McIntosh

MODEL NUMBER MA 230

MODIFICATION MA 230 serial #10C00 to # 13C03 to increase overall gain.

MODIFICATION INSTALLATION OF A 4 SECTION VOLUME CONTROL

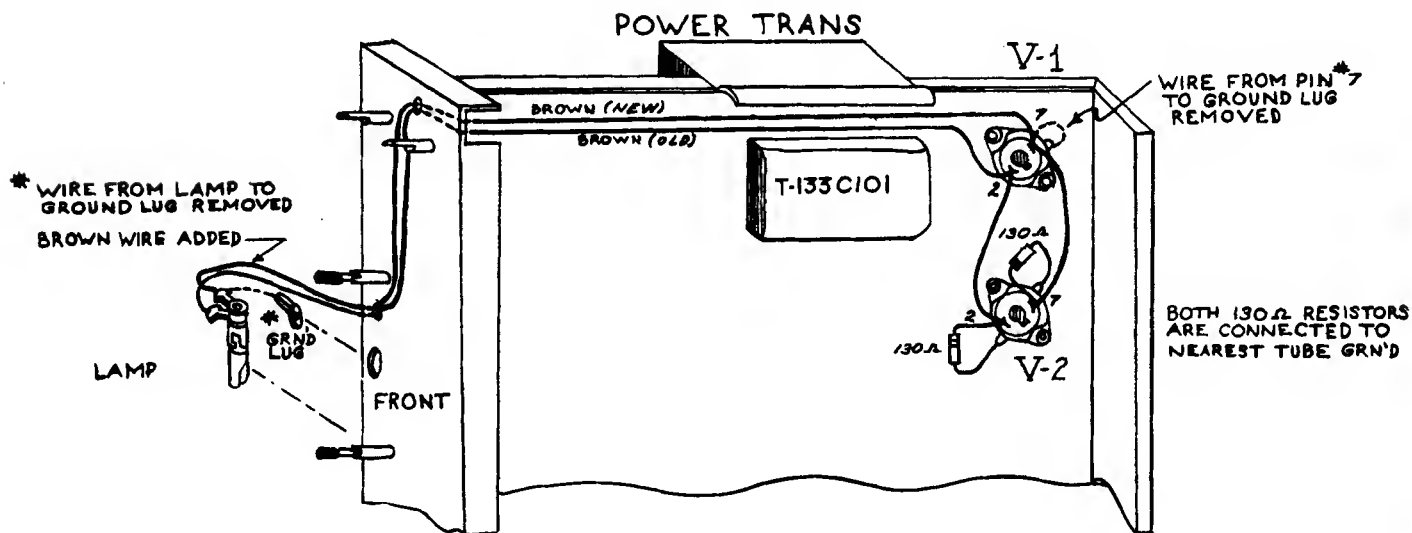
MODIFICATION MA 230 serial # 10C00 to # 17C50 to decrease hum introduced when H.F. filter switch is depressed.

DESCRIPTION This modification may be incorporated in MA 230 units with the above serial number to decrease hum introduced when the H.F. filter switch is depressed. The hum introduced comes from a 120 cycle ripple component on the filament supply coupling to the input grids of the 12AX7 tube. This coupling is eliminated by adding two resistors to balance the filament supply with respect to ground. The pilot lamp is rewired as a part of the modification.

1. Remove bare wire from pilot light socket to ground.
2. Remove bare wire from pin 7 of V₁ to ground.
3. Install new wire to pilot light and two 100 ohm 10% ½ watt resistors as shown below:

MA-230 INSTALLATION OF 4-SECTION VOLUME CONTROL

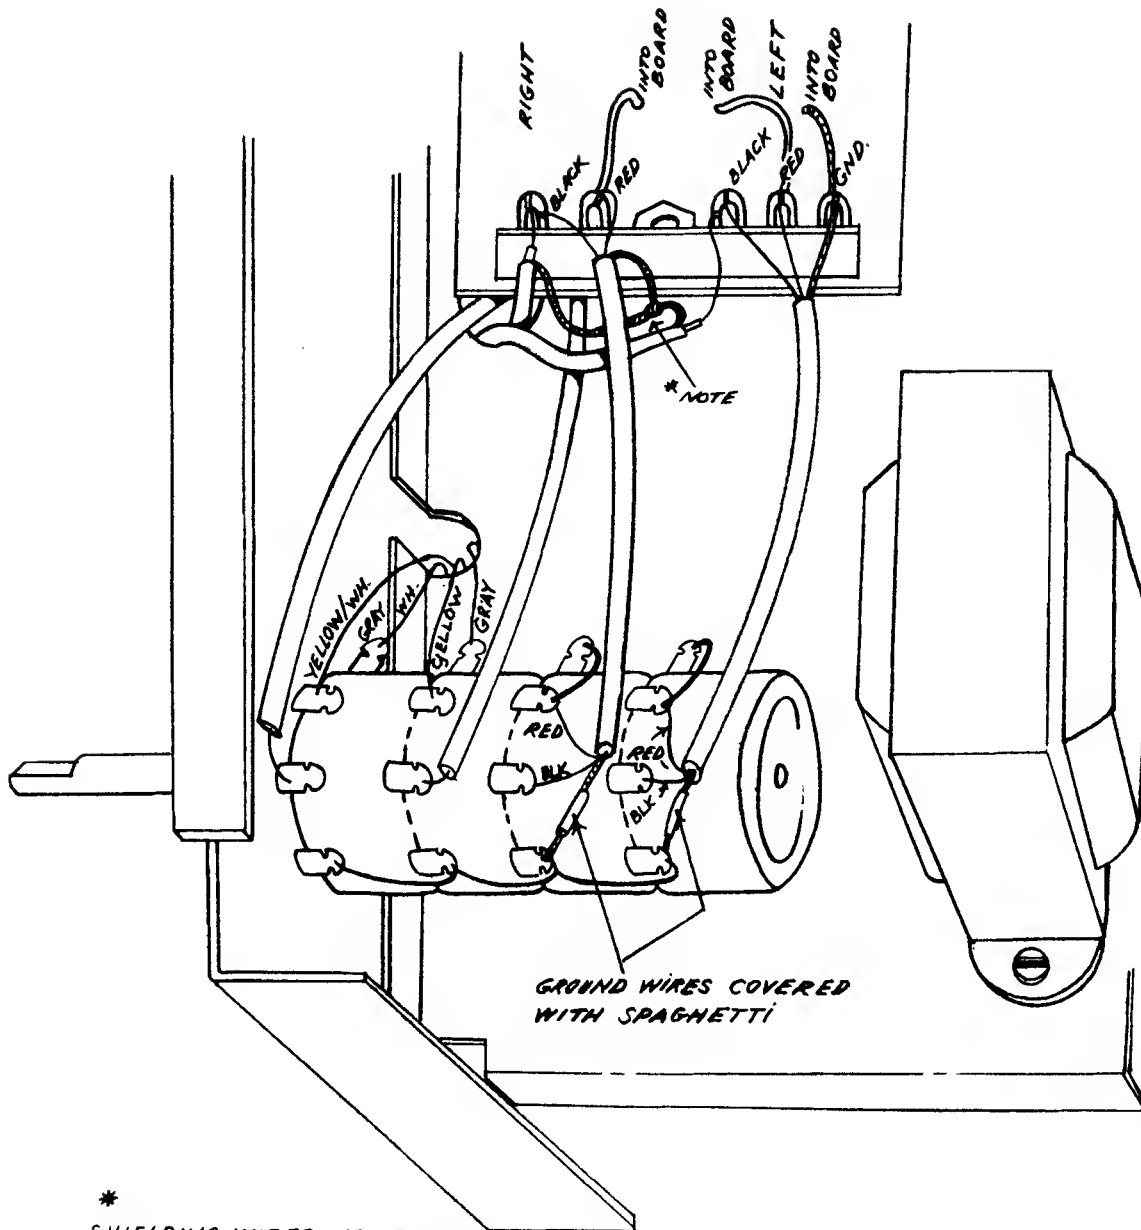
1. Remove the black ground wire running from the volume control to the balance control.
2. Install terminal strip on the printed circuit board. Use the existing bolt and nut.
3. Cut the audio cables attached to the card. Cut them long enough to be connected to the terminal strip as shown in the diagram.
4. Remove the existing volume control. Pay strict attention to how the wires are connected. (The two front sections of the new volume control are identical to the existing control; the two rear sections are those added.)
5. Install the new volume control and wire according to the diagram. Connect the 5 jumper wires. Make sure they are insulated from the control frame. Use insulated wire or spaghetti. Do not alter the lead arrangement or the grounding method. Hum may be introduced if you do so.

* SHIELDING WIRES FROM THESE CABLES ARE TIED TOGETHER
